**MEMORANDUM**

**SUBJECT:** Mandatory Referral No. 08404-MCPS-1: Cabin John Middle School  
Modernization Project -10701 Gainsborough Road, R-90 Zone,  
2002 Potomac Subregion Master Plan

Approval to transmit the following comments to Montgomery County Public Schools:

# ATTACHMENT 4 PROPOSED SITE PLAN

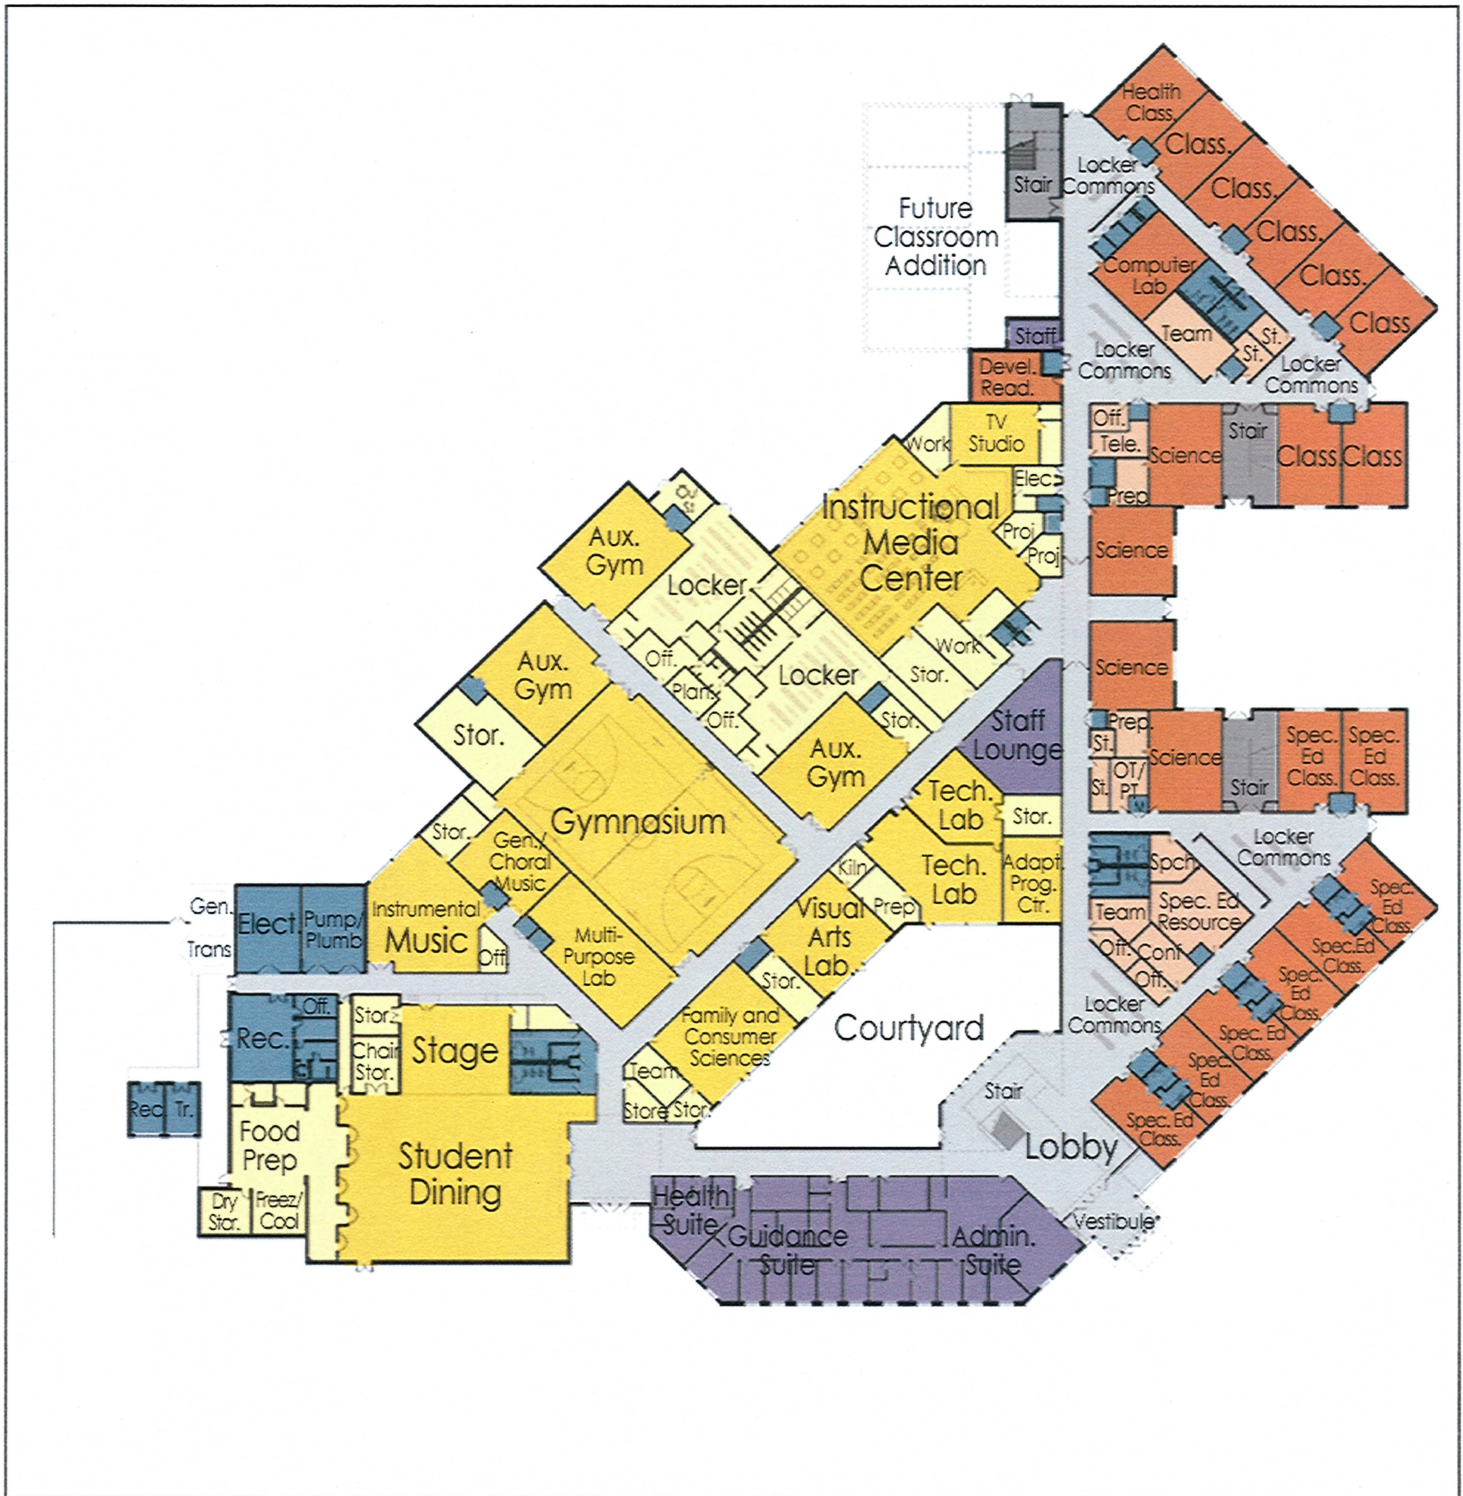
1. Provide a traffic study for any future building additions if the school's core capacity is increased above 1,200 students.
2. Discourage parent drop-off/pick-up of students along Gainsborough Road and Bells Mill Road.
3. Notify Community Use of Public Facilities six months in advance of construction that will prohibit community use of playing fields.

Finally, while a vegetated roof is not required to meet LEED certification or stormwater management requirements, it is strongly recommended that MCPS use this type of green roof on school modernization projects. This is especially critical on sites that have difficulty providing above ground water quality control due to configuration or size.

1. Provide a traffic study for any future building addition if the school's core capacity is increased above 1,200 students.
2. Discourage parent drop-off/pick-up of students along Gainsborough Road and Bells Mill Road.
